CHAPTER 2 ALTERNATIVES

This Chapter summarizes the alternatives to the Project that were fully evaluated in the Draft Environmental Impact Statement/Environmental Impact Report (EIS/EIR) published in September 2015,¹ and describes minor changes to one of those alternatives (the Hybrid Alternative) as a result of public comments on the Draft EIS/EIR.

2.3 Changes to the Staff-Recommended Alternative

The three modifications to the Hybrid Alternative/SRA are detailed below. **Figure 2-5** depicts detail of the Hybrid Alternative/SRA, inclusive of these three modifications.

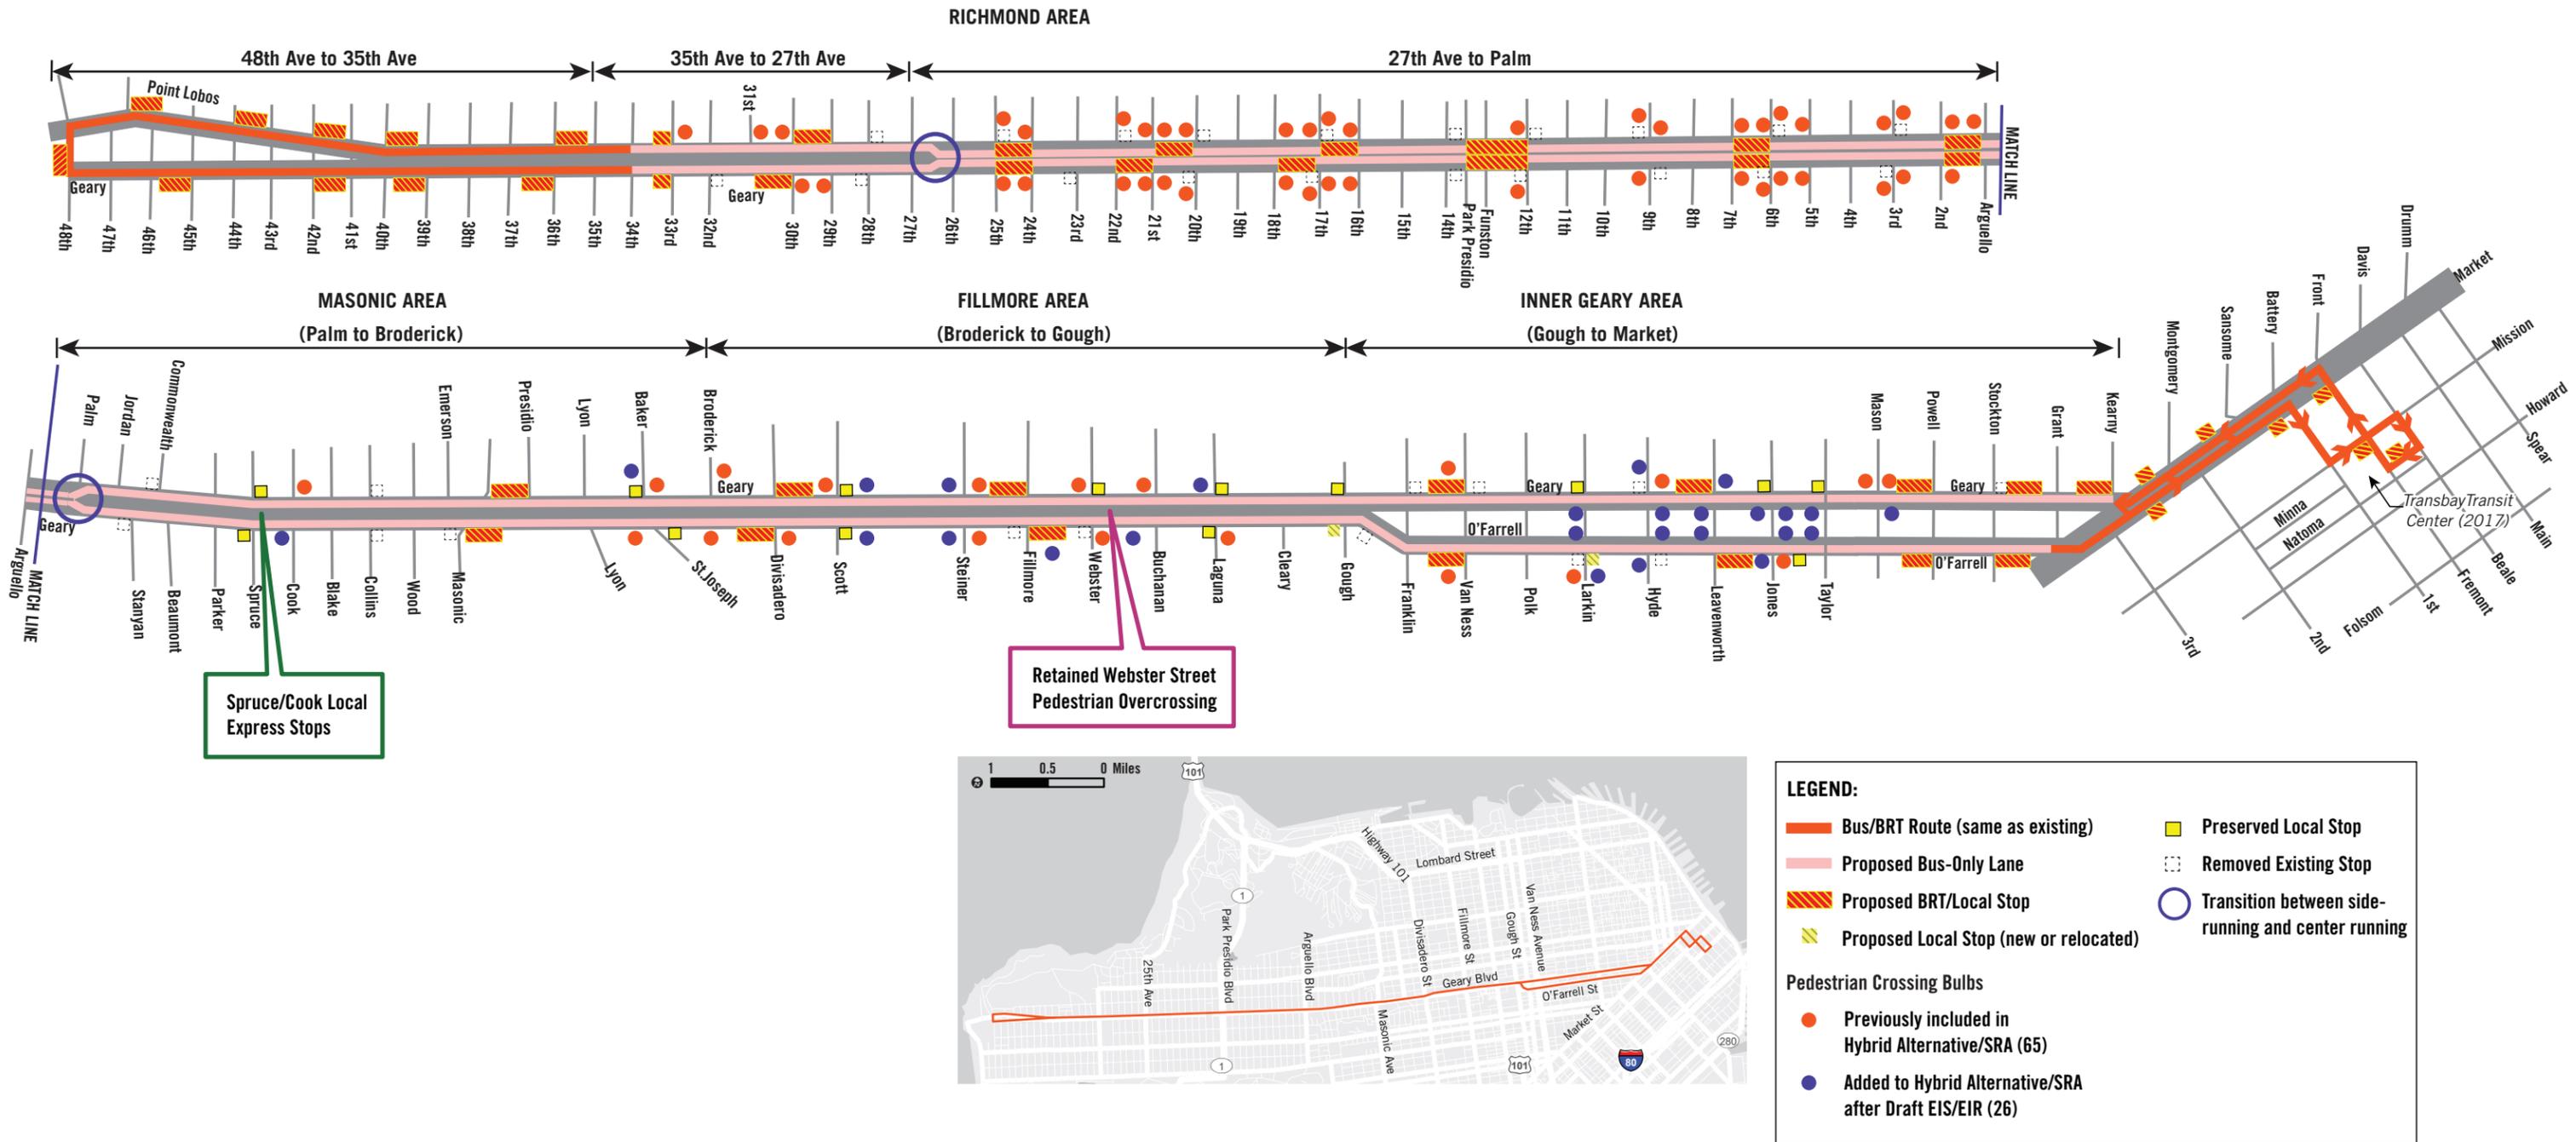
Several commenters expressed opposition to the proposed BRT stops, citing concerns over the loss of all the on-street parking spaces on this particular block. Numerous commenters cited such parking loss as detrimental to businesses.

Following publication of the Draft EIS/EIR, SFCTA and SFMTA consulted extensively with stakeholders in this area to contemplate potential project changes. The local agencies ultimately proposed to modify the Hybrid Alternative/SRA to drop the two BRT stops proposed for this area. Instead, the Hybrid Alternative/SRA would incorporate the current bus stops (westbound, on the near side of Spruce; eastbound, also on the near side of Spruce) as local and express stops. In other words, these two stops would retain their existing physical configurations and services under the Hybrid Alternative/SRA.

Substantial concern regarding removal of this bridge was expressed through comments on the Draft EIS/EIR by agencies, organizations, and individuals. Many commenters questioned the safety of proposed new ground-level crossings, particularly for groups of children attending nearby schools. For more information, see **Appendix B**.

Following publication of the Draft EIS/EIR, SFCTA and SFMTA met with stakeholder groups, including several who submitted comments on this particular issue. In studying the issue more closely, SFCTA and SFMTA found that retaining the Webster Street bridge would result in minor impacts to bus service of several seconds that would not substantially affect travel times throughout the corridor, and therefore the bridge could be retained without substantial negative impact on bus rapid transit service.

In response to comments on the Draft EIS/EIR regarding pedestrian safety, SFCTA and SFMTA have added several similar pedestrian realm enhancements to the Hybrid Alternative/SRA. These are: 26 additional pedestrian bulbs (for a total of 91), a painted safety zone at Taylor and O'Farrell Streets, and daylighting at strategic intersection locations along the Geary corridor.³ **Figure 2-5** shows these added features in detail, including the 65 locations for pedestrian crossing bulbs originally proposed plus the 26 additional ones added to the Hybrid Alternative/SRA.⁴ The additional bulb locations were added to improve safe pedestrian travel to transit stops as well as to address areas where pedestrian injury rates are high.

Therefore, SFCTA and SFMTA have modified the Hybrid Alternative/SRA to retain the Webster Street pedestrian bridge. In addition, the Hybrid Alternative/SRA has been modified to add two pedestrian surface crossings on either side of the bridge:

- 1) A straight crossing on the west side of the intersection incorporating pedestrian refuge areas, and
- 2) A staggered crossing on the east side. The staggered crossing would improve pedestrian sight distance at the westbound frontage road, as pedestrians would cross in front of the existing bridge piers so they would not be obstructed behind the pier when crossing. Signal timing would be designed to allow pedestrians to cross in one cycle, with multiple wide medians providing pedestrian refuge areas across Geary. A pedestrian barrier would be installed on the center median of the staggered crossing to guide pedestrians to the second crossing.

In the westbound direction, no dedicated bus lane would exist at the Webster Street approach. Buses could either share the outside lane with right-turning vehicles, or share the through lane with frontage road traffic. A westbound side-running bus-only lane would reinitiate after crossing the Geary/Webster Street intersection.
